Well Name: HUERFANO UNIT**Well Location:** T26N / R10W / SEC 12 /
NENE / 36.507156 / -107.841324**County or Parish/State:** SAN
JUAN / NM**Well Number:** 185E**Type of Well:** CONVENTIONAL GAS
WELL**Allottee or Tribe Name:****Lease Number:** NMSF081024**Unit or CA Name:** HUERFANO UNIT--
DK**Unit or CA Number:**
NMNM78395C**US Well Number:** 3004526429**Operator:** HILCORP ENERGY
COMPANY

Sundry ID: 2886224**Type of Submission:** Subsequent Report**Type of Action:** Plug and Abandonment**Date Sundry Submitted:** 12/10/2025**Time Sundry Submitted:** 09:24**Date Operation Actually Began:** 12/01/2025**Actual Procedure:** The subject well was plugged and abandoned on 12/9/2025 per the attached daily report.

HUERFANO UNIT 185E**30.045.26429****PLUG AND ABANDONMENT**

From: Diede, Loren, EMNRD <Loren.Diede@emnrd.nm.gov>
Sent: Monday, December 8, 2025 3:01 PM
To: Rennick, Kenneth G; Oscar Sanchez - (C); Joe Zimmerman
Cc: Lucero, Virgil S; Dobson, Jimmie P; Farmington Regulatory Techs
Subject: RE: [EXTERNAL] HUERFANO UNIT 185E (30.045.26429) PLUG CHANGE REQUEST

Current Schematic - Version 3

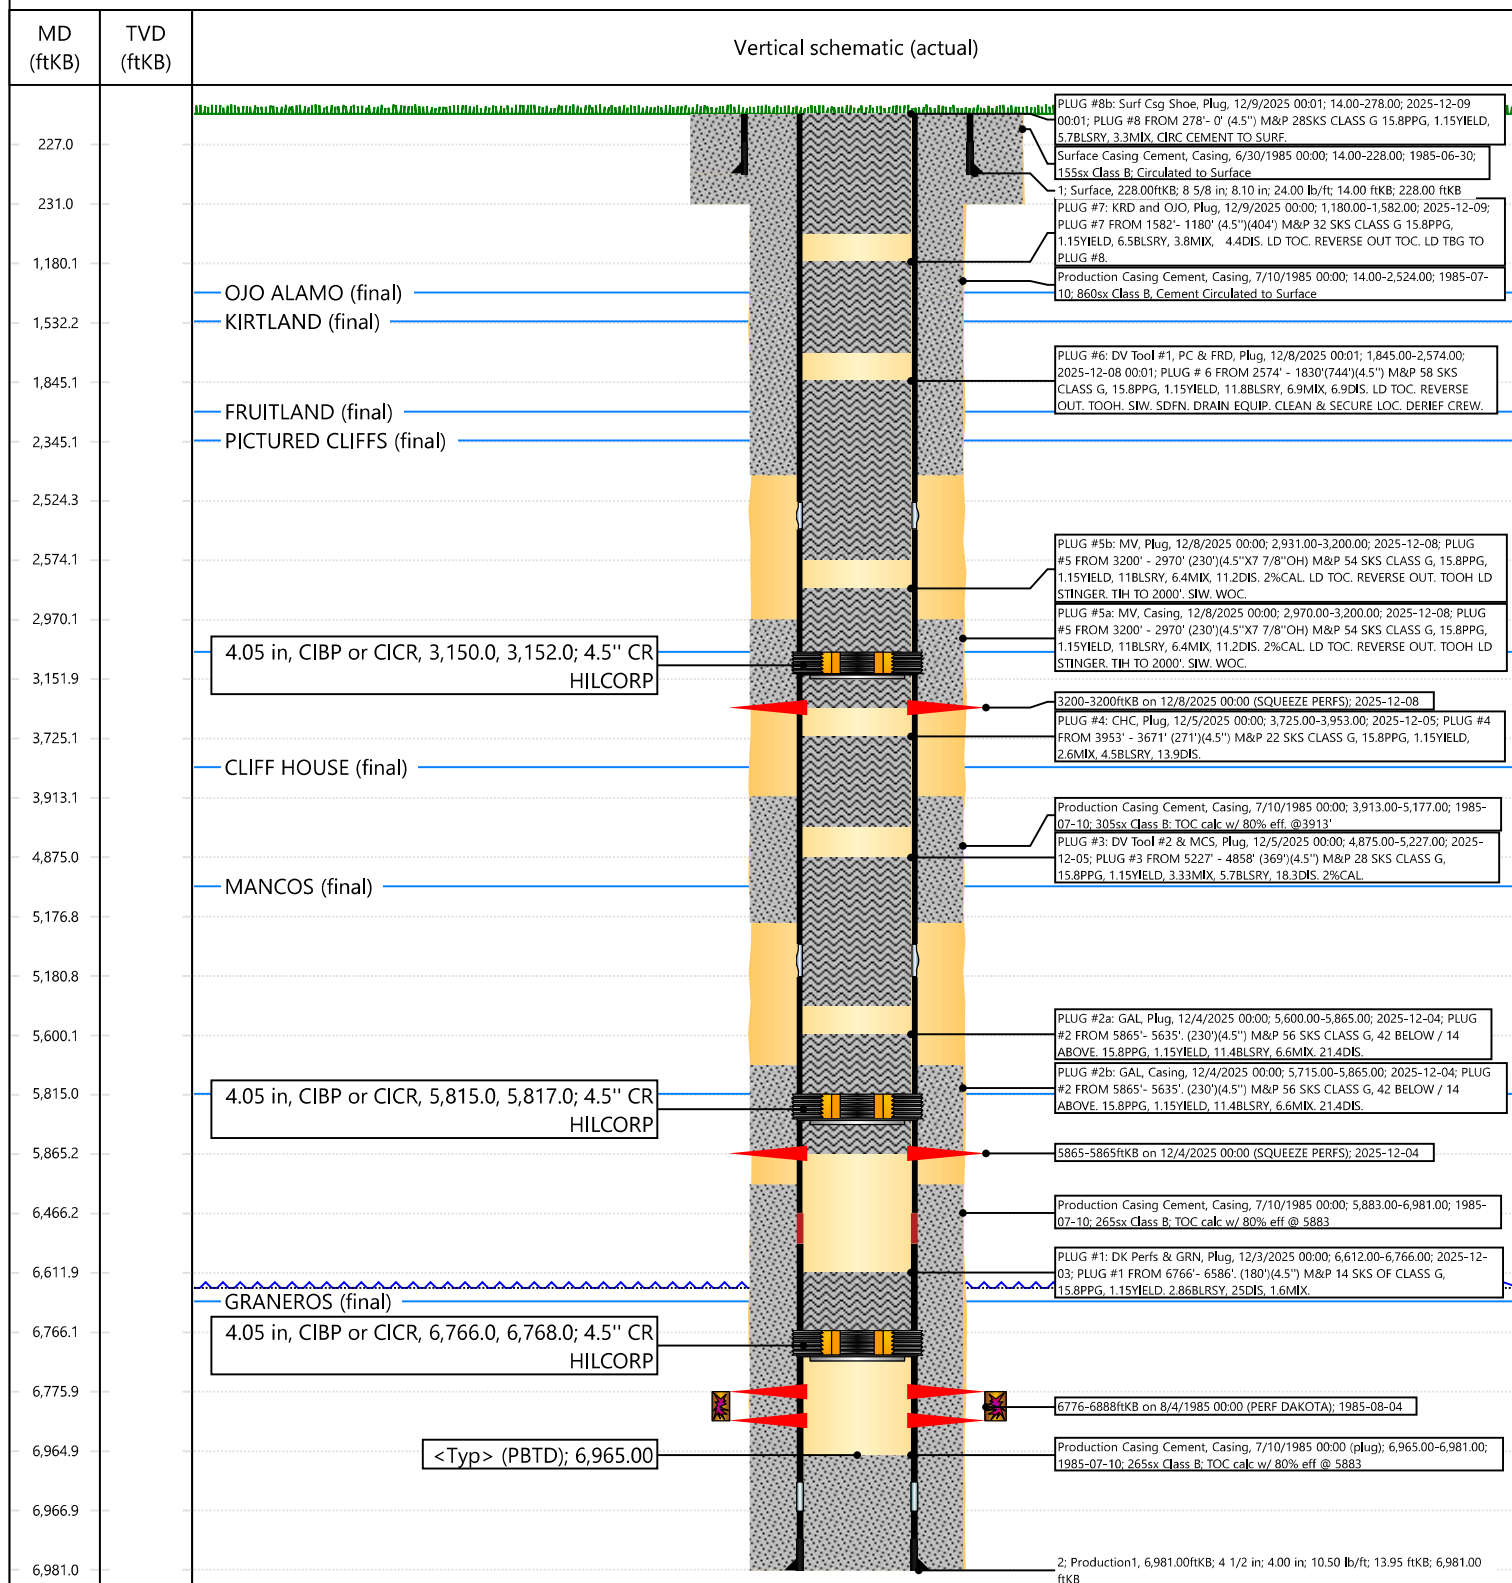
GOOD AFTERNOON... PER CBL (11-3-2025) PLUG #8 (CSG SHOE / SURF) CALLS FOR PERFS @ 278'. CBL IS SHOWING GOOD CEMENT BEHIND PIPE FROM 250' TO SURF. FURTHERMORE, NO PAST OR PRESENT BH PSI SINCE BEGINNING OF P&A OPERATIONS. REQUESTING TO CHANGE PLUG TO A BALANCED INSIDE PLUG FROM 278' – SURF CIRC CLASS G TO SURF. ANY QUESTIONS OR CONCERNS PLEASE CONTACT ME.

GOOD MORNING... PER YESTERDAYS CBL (11-3-2025) PLUG #4 (MV) THE FORMATION TOP IS @ 3903'. CBL IS SHOWING GOOD CEMENT BEHIND PIPE. REQUEST TO CHANGE PLUG TO A BALANCED INSIDE PLUG FROM 3953' – 3700' USING 20 SKS CLASS G. ANY QUESTIONS OR CONCERNS PLEASE CONTACT ME.

NMOCD agrees with BLM.

The BLM finds the procedure appropriate.

The BLM finds the updated procedure appropriate.
